**MUNICIPAL PLANNING COMMISSION AGENDA
SUMMER VILLAGE OF JARVIS BAY
SUMMER VILLAGES ADMINISTRATION OFFICE
AUGUST 2, 2023 @ 10:00 A.M.**

Agenda Item

158 Jarvis Bay Drive (Lot 5, Block 5, Plan 7278AA)

Development Permit Application

Wall cross section
158 Jarvis Bay Dr.

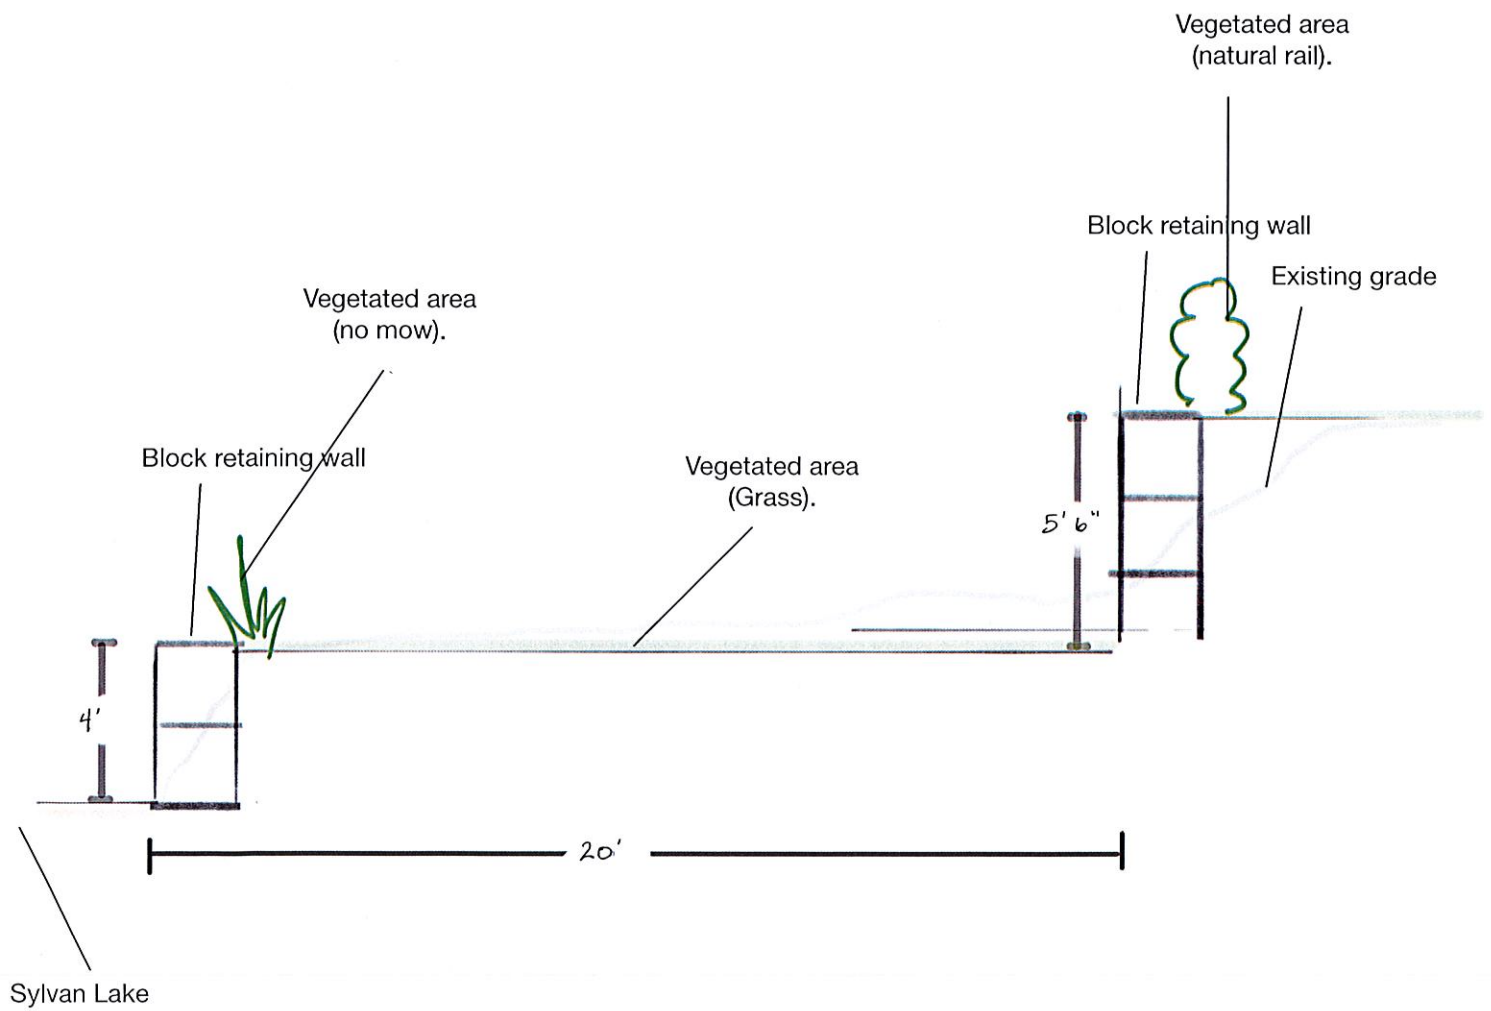
Along with this report, the applicant has included a site plan and cross section showing the proposed placement of the tiered retaining walls, the new stairs, new vegetation, and existing and proposed grades. The proposed walls measure 4ft. tall, 5ft tall, and 20ft. apart. The site plan and cross section include a minimum 1m no mow zone as well as grass and vegetated plantings along the top retaining wall and between properties. The new stairs are proposed to be a precast rock as shown in the picture provided, to drop down from the top of each retaining wall. A minimum of 20 new plantings are to be planted.

- Land Use Bylaw, Part Three 4.4 (f) Retaining walls greater than 1m (3.28ft.) in height above any adjoining grade requires a development permit. The proposed walls being 1.21m (4ft.) and 1.67m (5.6ft) require variances, therefore the decision must come from the Municipal Planning Commission.

In administrations opinion the retaining walls are not required to stabilize the bank and the geotechnical report is not stating that the bank is failing and requires the work to take place. While it is an understanding the retaining walls will improve the factor of safety, it does not appear the development is necessary. Administration supports as much new vegetation as possible being planted in order to reduce any potential bank erosion or sediment loss. Variances shall be considered only where warranted by the merits of the proposed development and in response to irregular parcel lines, parcel shapes or site characteristics which create difficulties in siting structures within the required setback or in meeting the usual bylaw requirements.

- All recommendations in the geotechnical report to be followed and construction inspections to be completed by the engineer.
- Engineered drawings to be provided for the construction of the walls.
- Planting of shrubs and trees to be done according to the landscaping plan. The no mow zone shall be a buffer strip of vegetation that includes native plantings that let aquatic vegetation grow to maintain a stable natural state, a no mow zone allows native plants to seed and reestablish.
- The payment of a \$3,000.00 completions deposit to ensure all conditions of this development permit have been met, including the completion of building construction within a one-year period, landscaping completed within two years, and any or all road damage repaired.

Wall locations

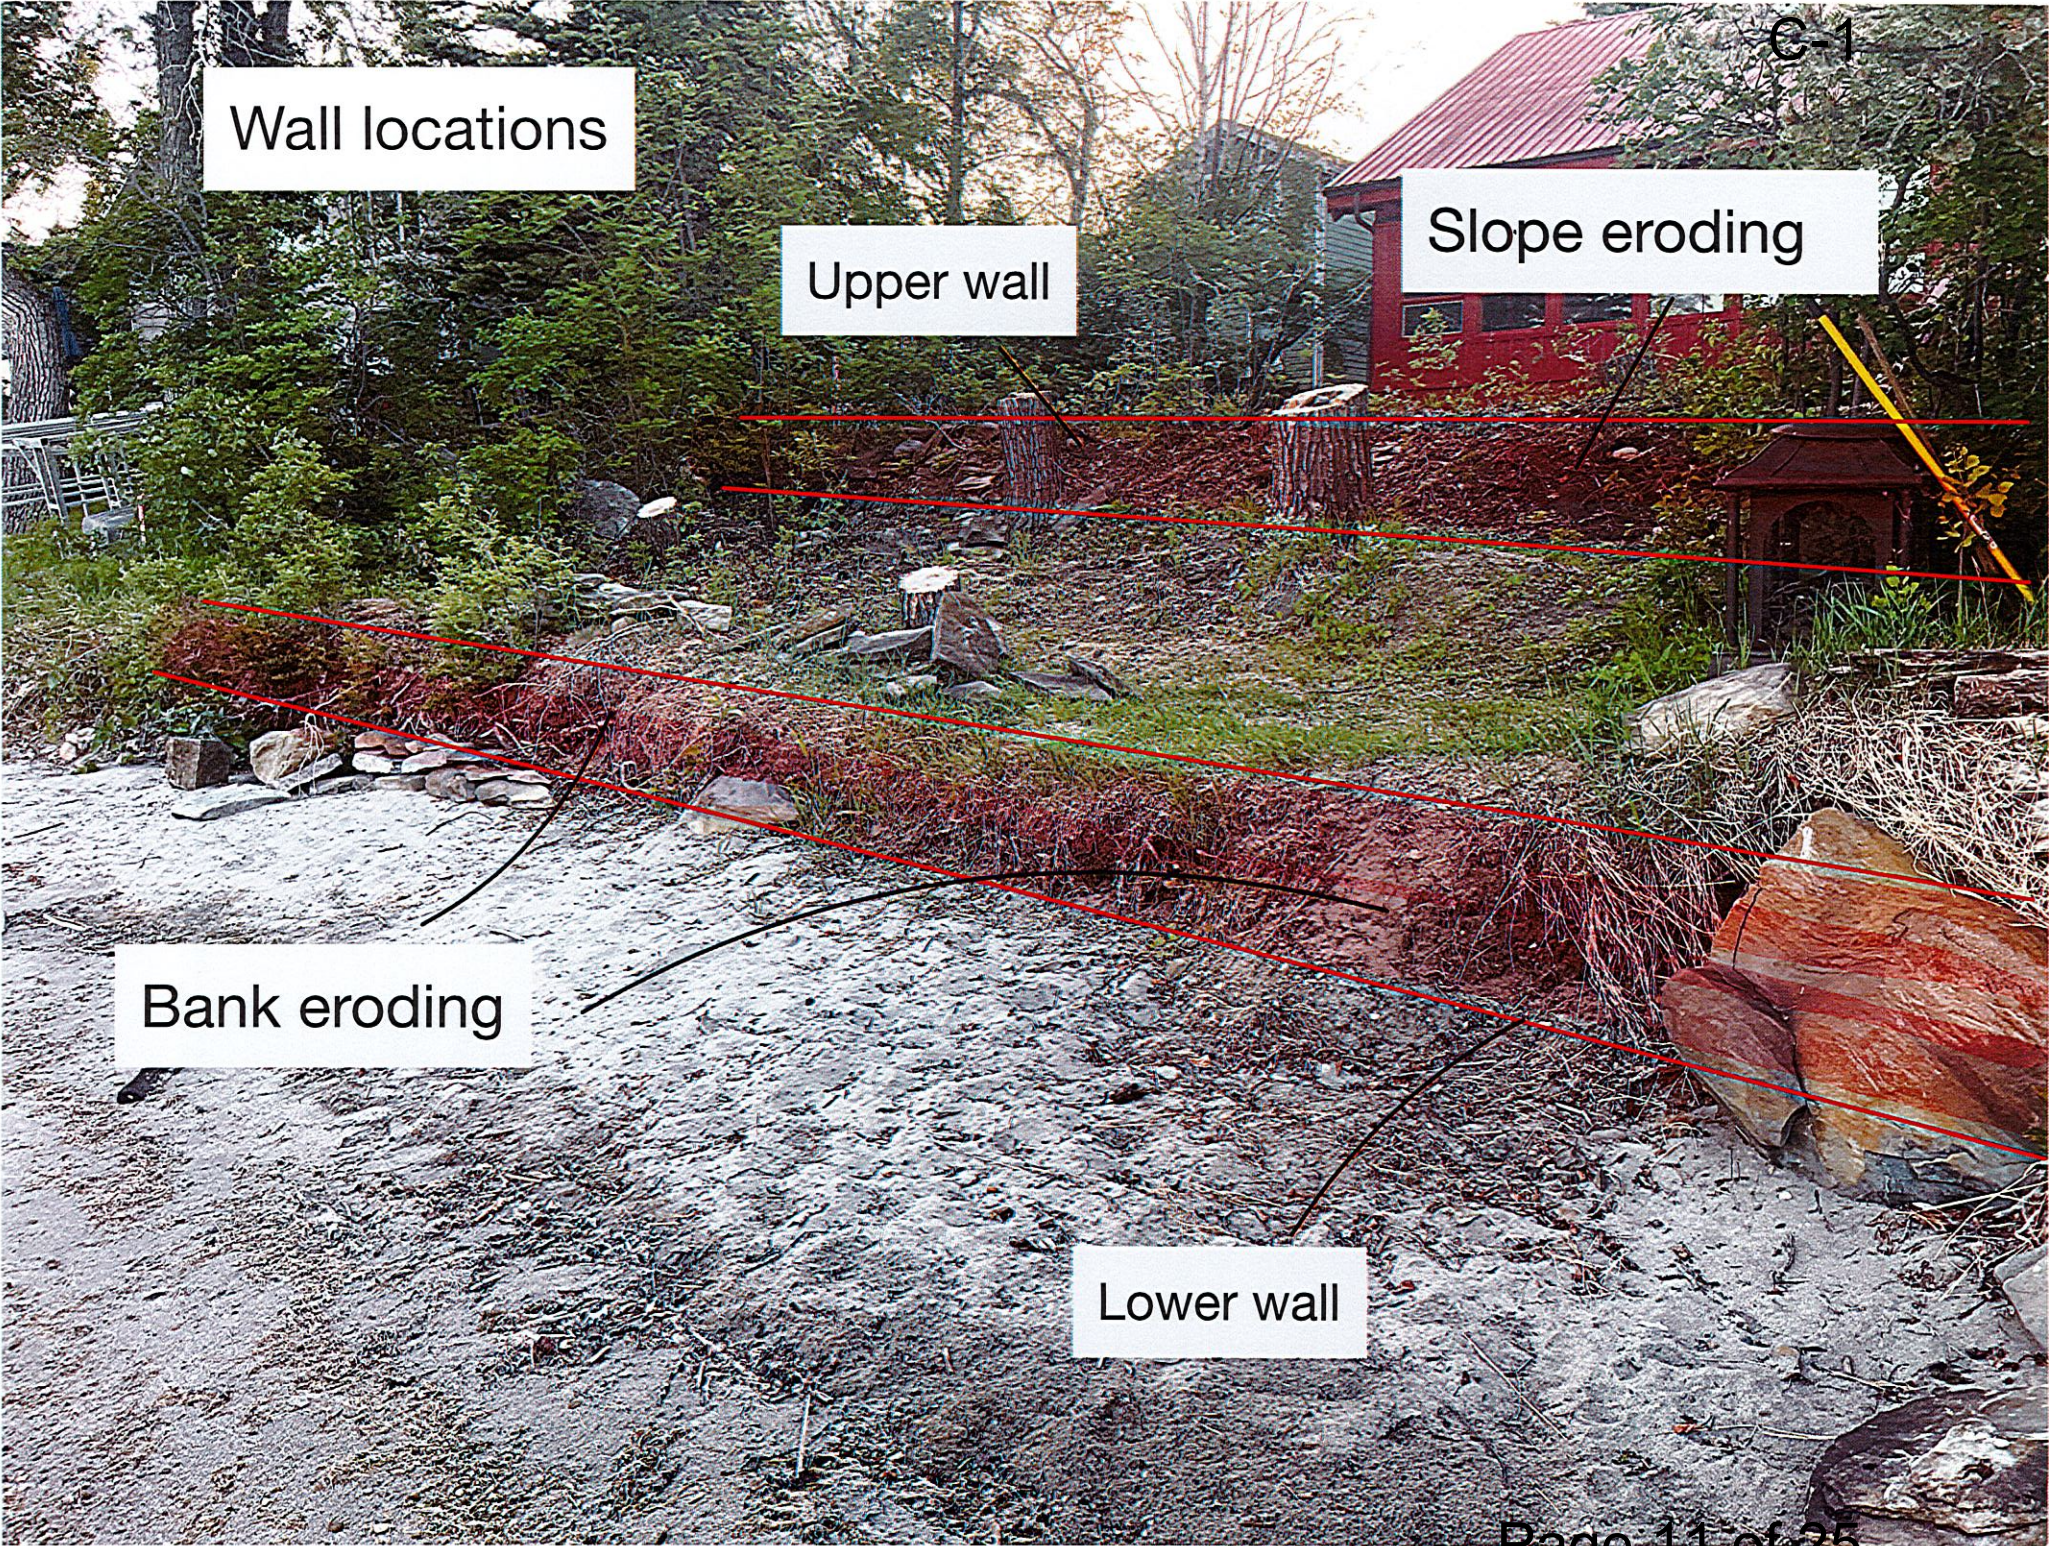
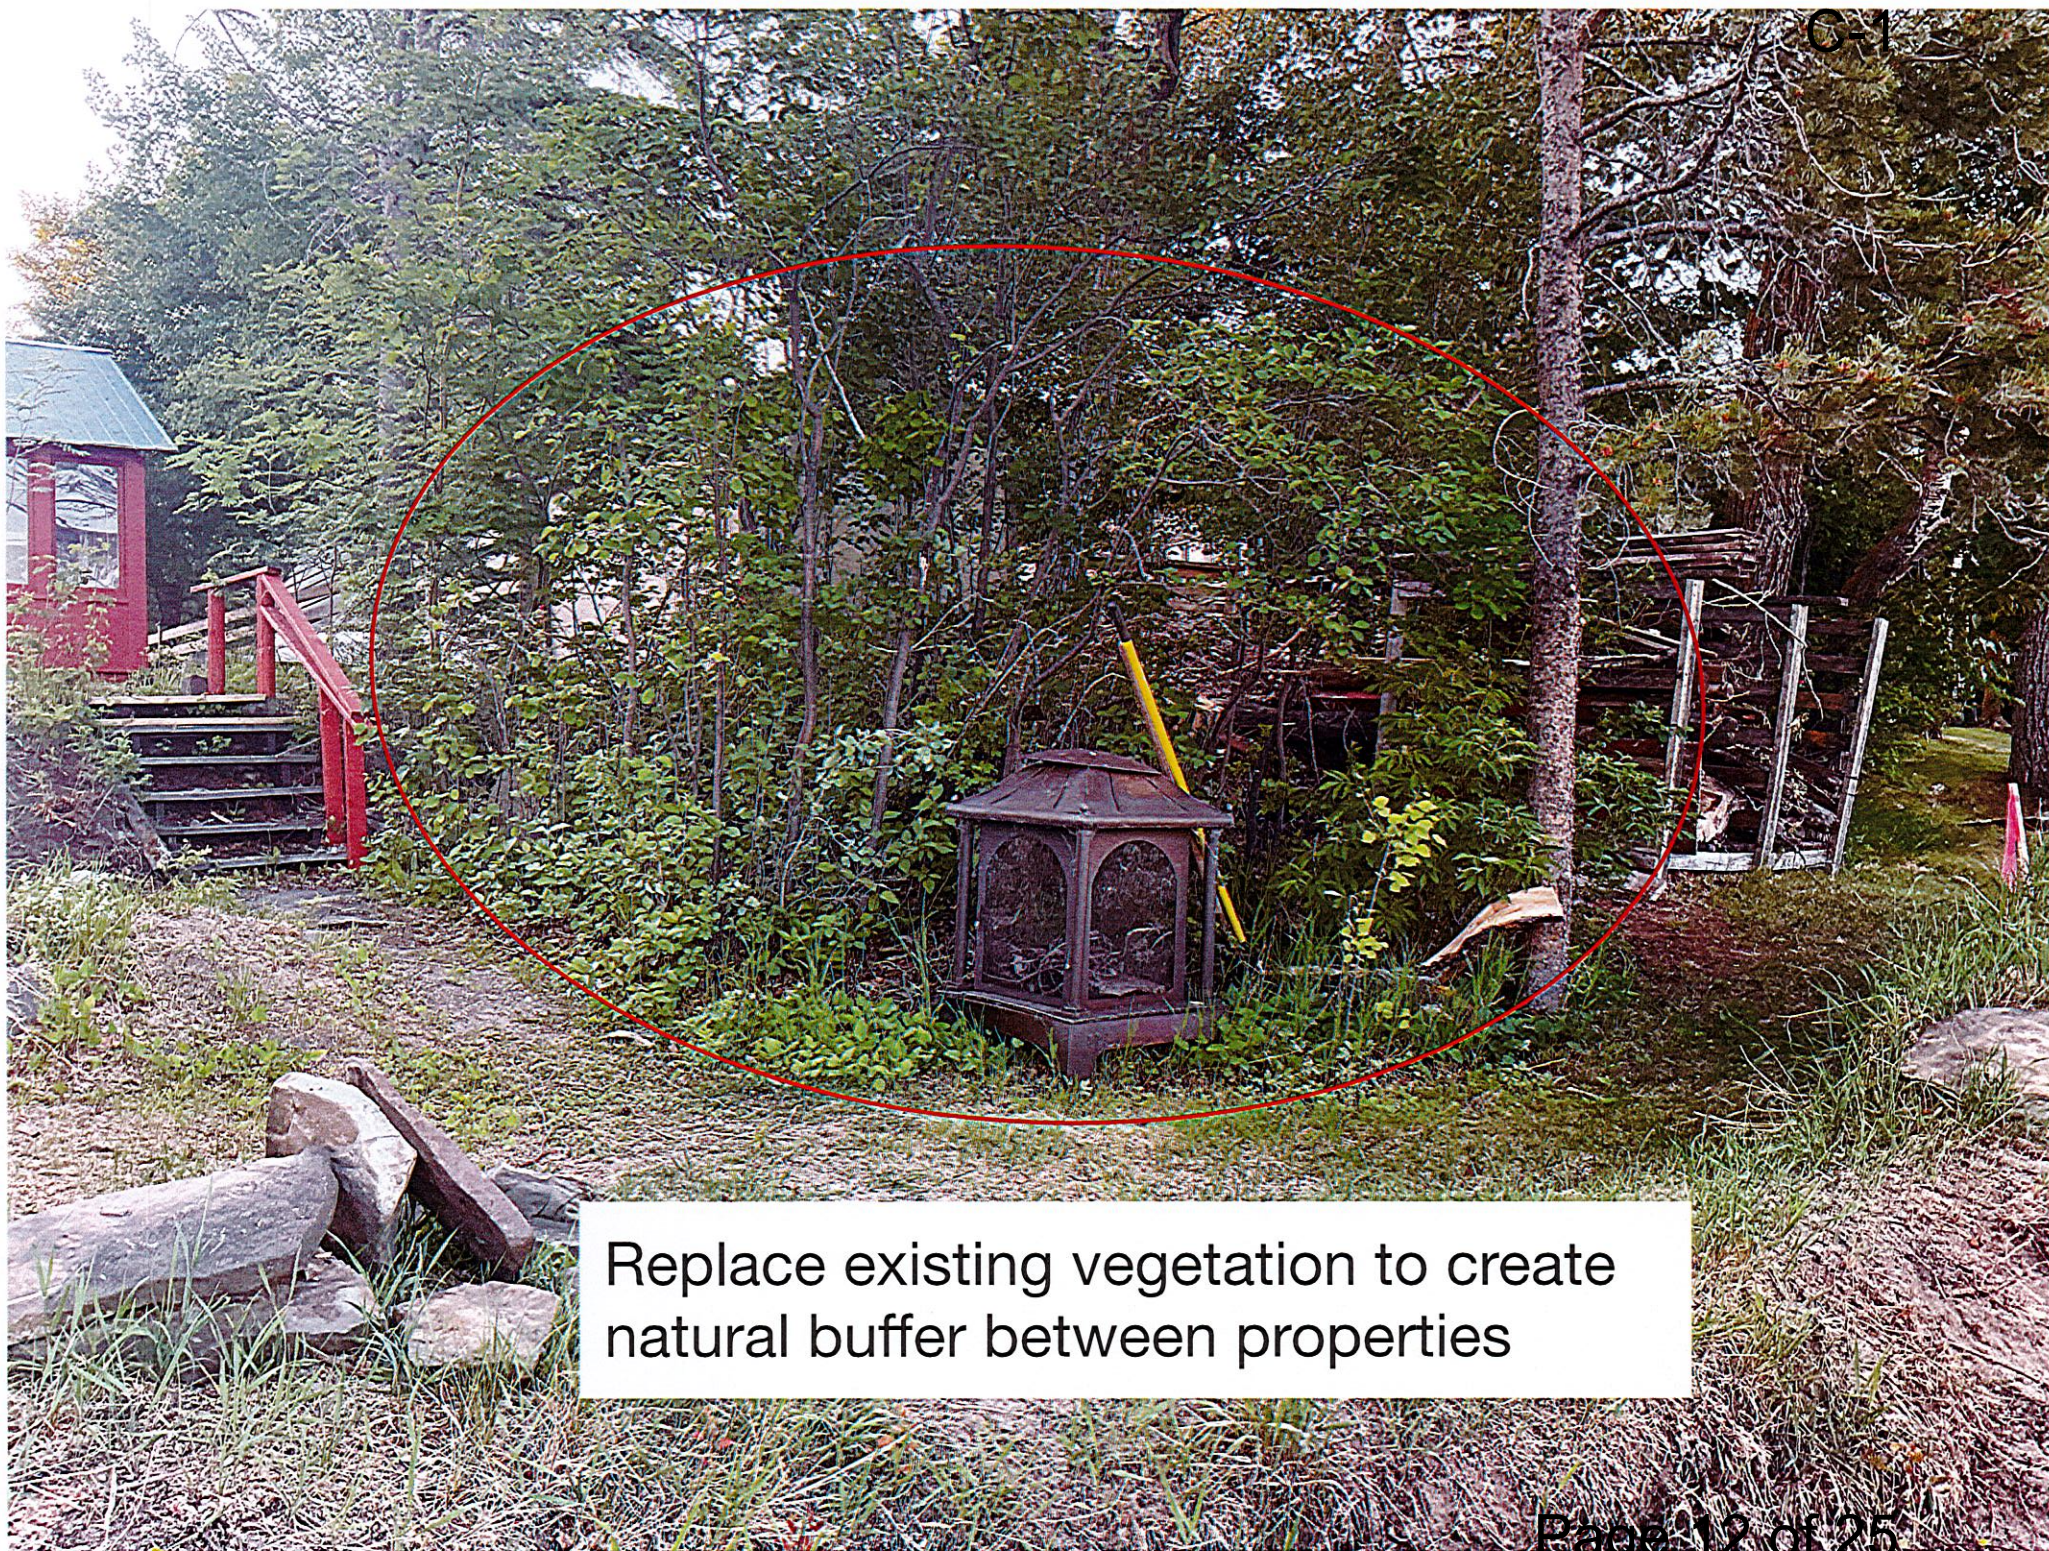
The lower wall will be constructed adjacent to the eroded bank as shown in the provided photos. The end result will be similar to the walls recently installed at 152 and 166 Jarvis Bay Dr. There is an elevation change that is difficult to maintain and hazardous for the recreational use of the yard. The upper wall will be installed along the existing elevation change on the property which is approximately 20' behind the proposed lower wall. Vegetation will be added above the upper wall to become a natural railing for safety. Care will be taken to preserve as much of the existing vegetation as possible to aid in the stabilization of the area and also provide privacy and a more natural appearance. The area between the two walls will be a grassed and vegetated surface. Precast faux rock steps will be used for access to the lakeshore to create a more natural look. A 1m no mow zone will be left to separate the private property and the lake.
